Re: Comment Response Letter:
Response and Development Work Plan (Rev. 0)
Area A: Sub-Parcel A11-2
Tradepoint Atlantic
Sparrows Point, MD 21219

On behalf of Tradepoint Atlantic (TPA), ARM Group LLC (ARM) is pleased to provide the enclosed responses to comments received from the Maryland Department of the Environment (MDE) via email on May 19, 2021 regarding the recent Response and Development Work Plan (RADWP) for the portion of the TPA property designated as Area A: Sub-Parcel A11-2 (the Site). The RADWP (Revision 0 dated March 11, 2021) was submitted to the MDE and the United States Environmental Protection Agency (USEPA) to present the proposed development plan.

Re: Sub-Slab Soil Gas & Indoor Air
Monitoring Plan (Revision 1)
Area A: Sub-Parcel A11-2
Tradepoint Atlantic
Sparrows Point, MD 21219

Figure
1

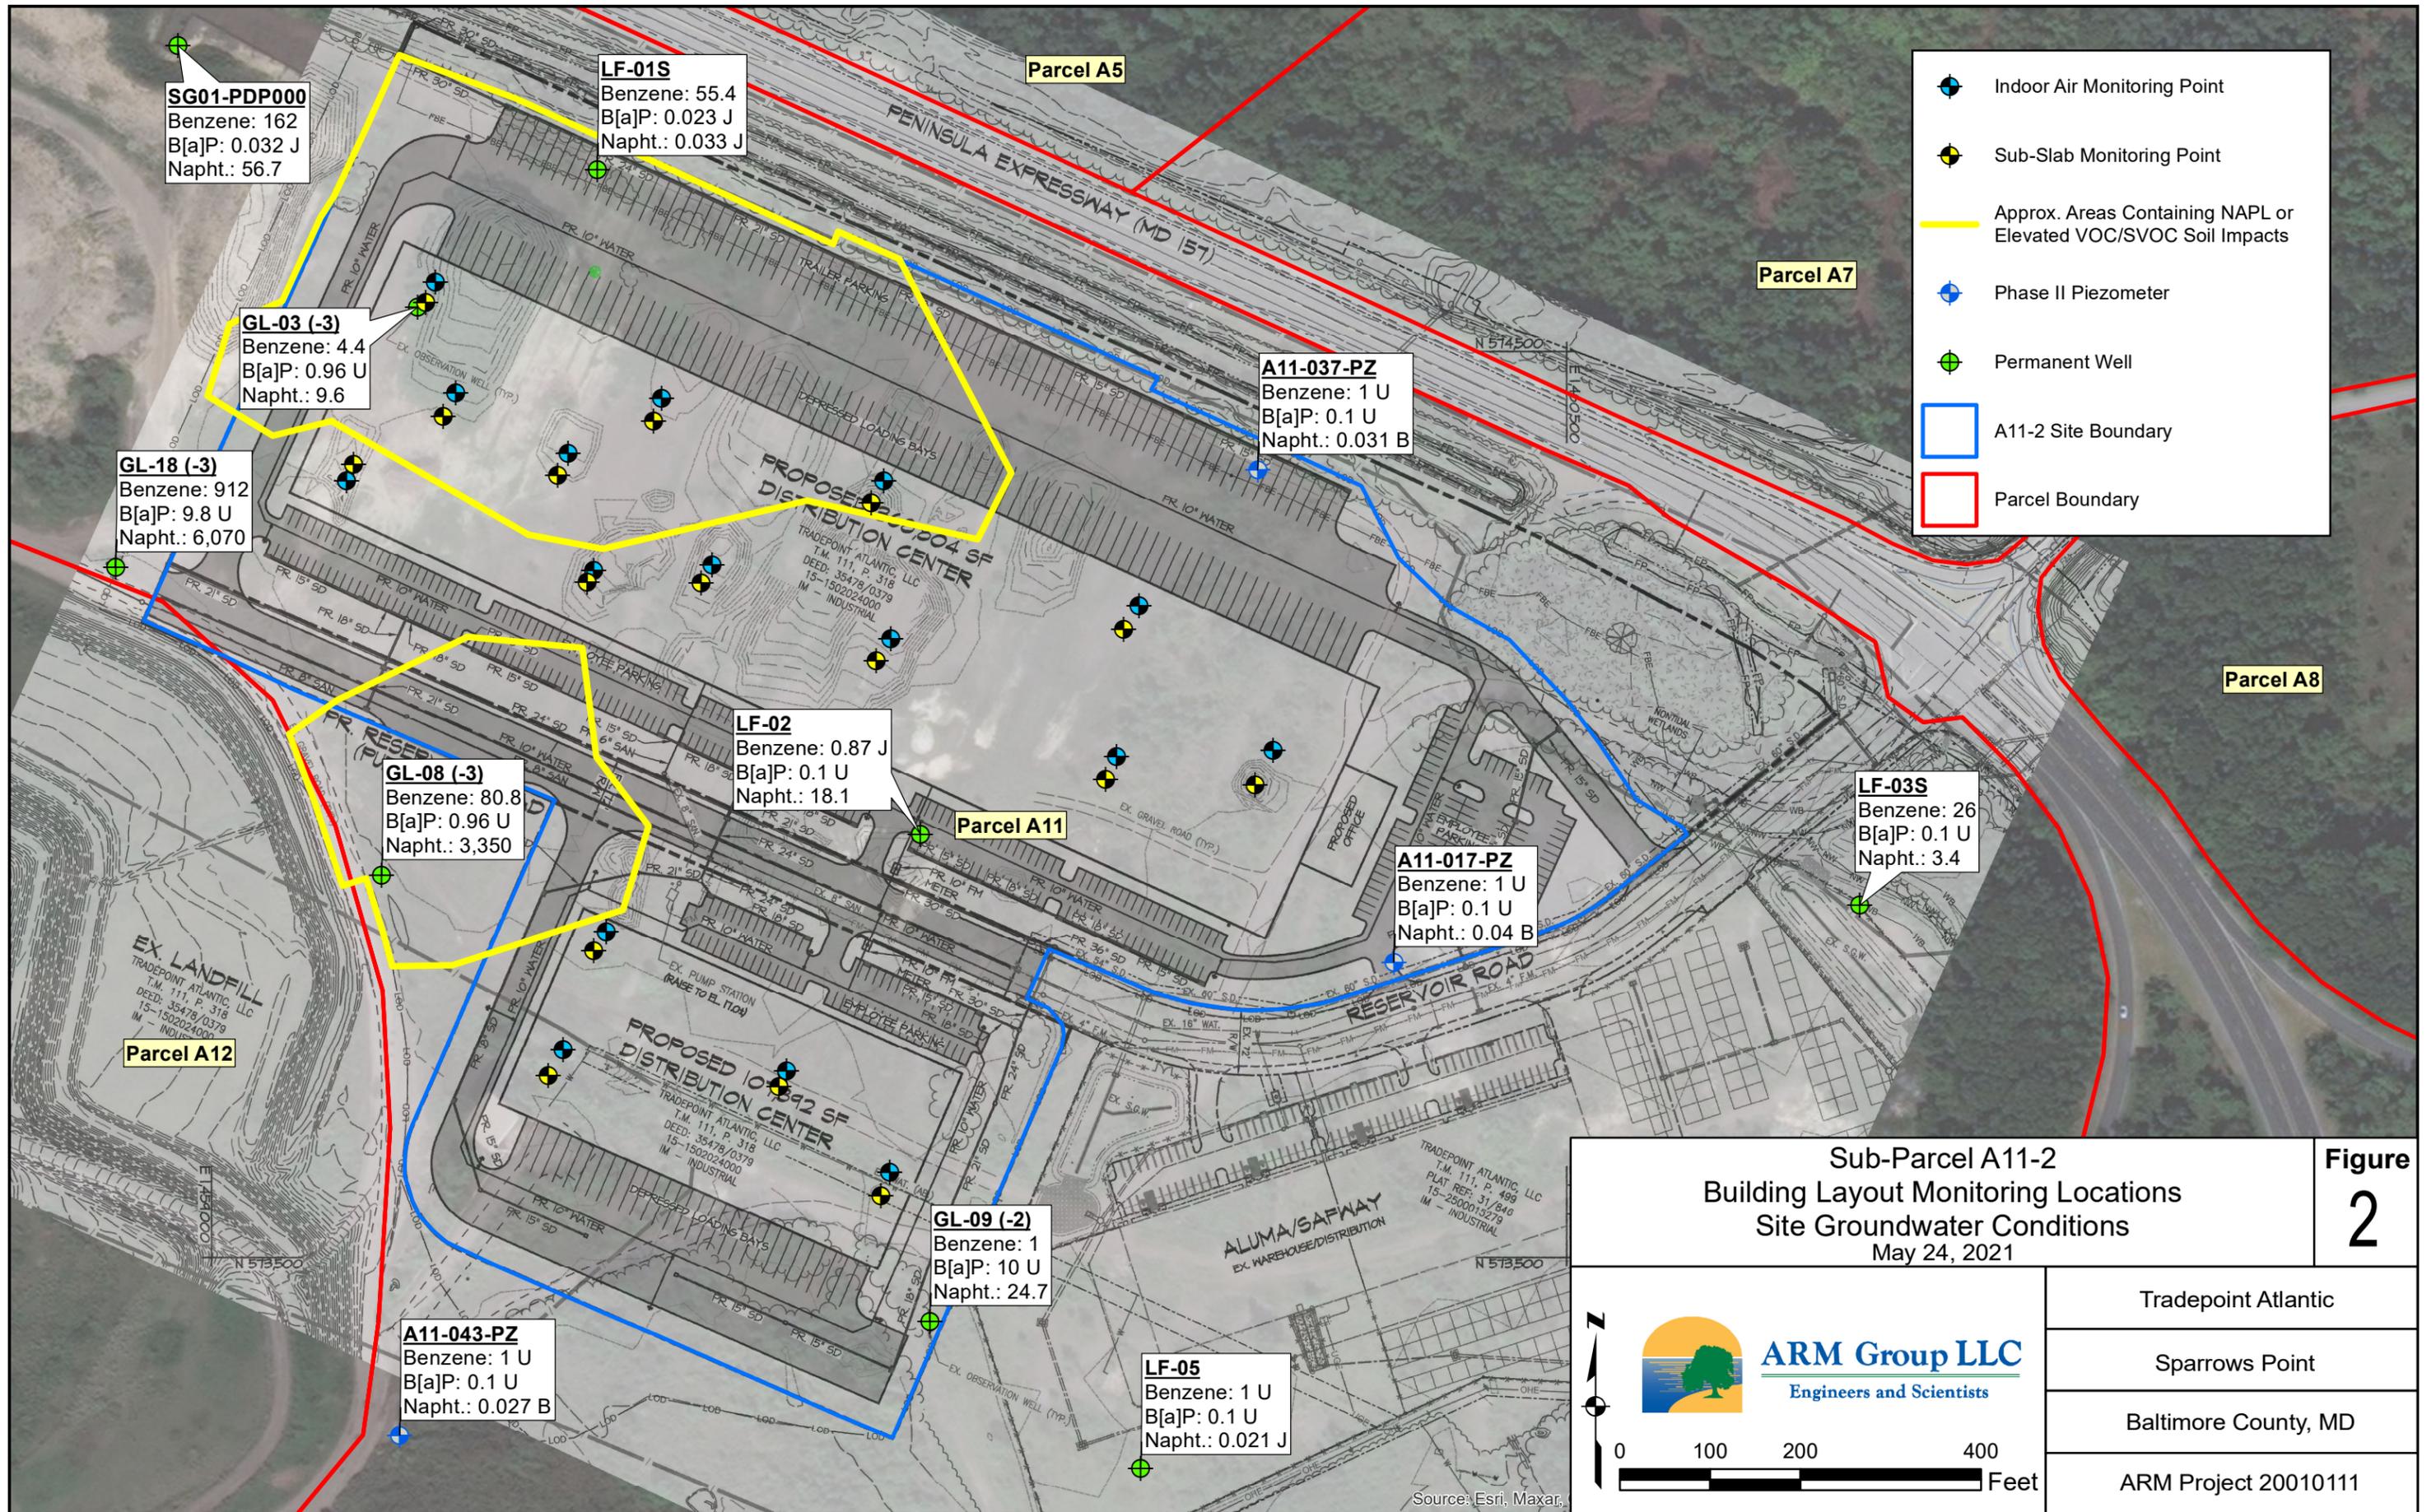
7. *Appendix G: Provide two figures, with the second overlaying the proposed monitoring locations on the well/piezometer and soil data.*

8. *Add at least two additional soil gas/indoor air sample locations to the 370,000 sq. ft. building, with one in the southwestern corner of the building, closest to the Grey's Landfill side of the property.*

9. *Add at least one additional soil gas/indoor air sample location to the 107,000 sq. ft. building.*

Three additional figures showing the proposed sub-slab soil gas / indoor air monitoring points are provided with this Comment Response Letter in the revised Sub-Slab Soil Gas & Indoor Air Monitoring Plan (provided as **Appendix G** to the RADWP). The figures include the additional monitoring points requested in Comments #8 and #9. **Figure 1** shows the monitoring points as they were shown in **Appendix G** of the RADWP. The site groundwater data are shown overlain on the monitoring points on **Figure 2**. The site soil data, summarized based on conditions above and below 5 feet below ground surface (bgs) as presented in the RADWP, are shown on **Figures 3a** and **3b**, respectively. The text of the Sub-Slab Soil Gas & Indoor Air Monitoring Plan has also been updated to reflect the new sample points and reference the new figures, but no other changes were made to the proposed monitoring plan, schedule, or protocols.

Two additional pairs of sub-slab soil gas / indoor air sampling points have been added to the 370,000 sq. ft. building. One pair has been added in the requested location closest to Greys Landfill. The proposed monitoring points are presented in the attached version of **Appendix G**.

An additional sampling pair has been added to the 107,000 sq. ft. building. The proposed monitoring points are presented in the attached version of **Appendix G**.
